ADDENDUM NO. 2

WASHINGTON STATE PARKS AND RECREATION COMMISSION SPOKANE RIVER CENTENNIAL STATE PARK TRAIL PAVING REPAIR AND OVERLAY EW-C6203

DATE: February 8, 2024

OVERLAY TRANSITION ALTERNATE
DETAIL

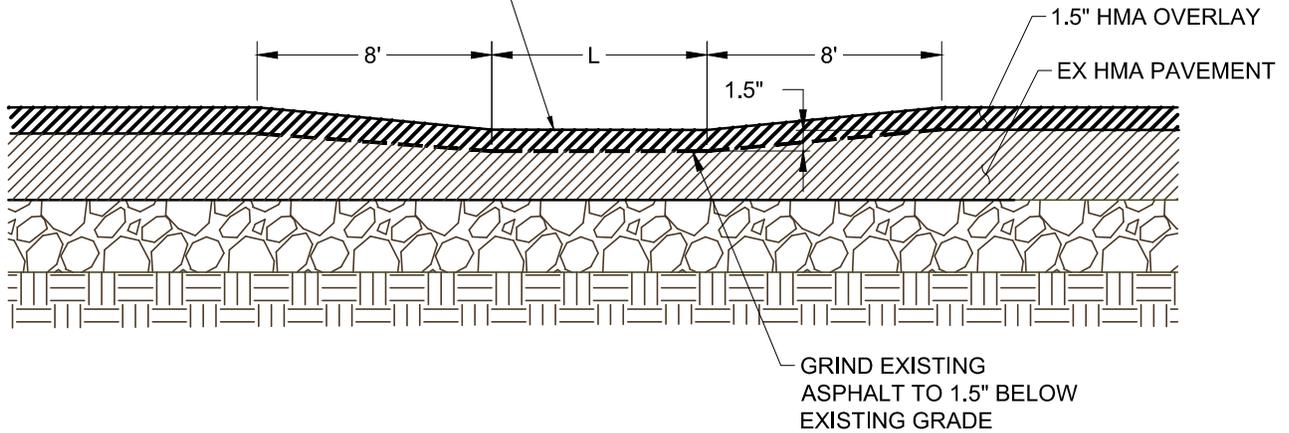
- B. **Sheet 43 of 45;** Detail D "Overlay Transition"; Attached Sketch SK-1 reflects an acceptable alternative Detail.

D OVERLAY TRANSITION
SCALE: NTS
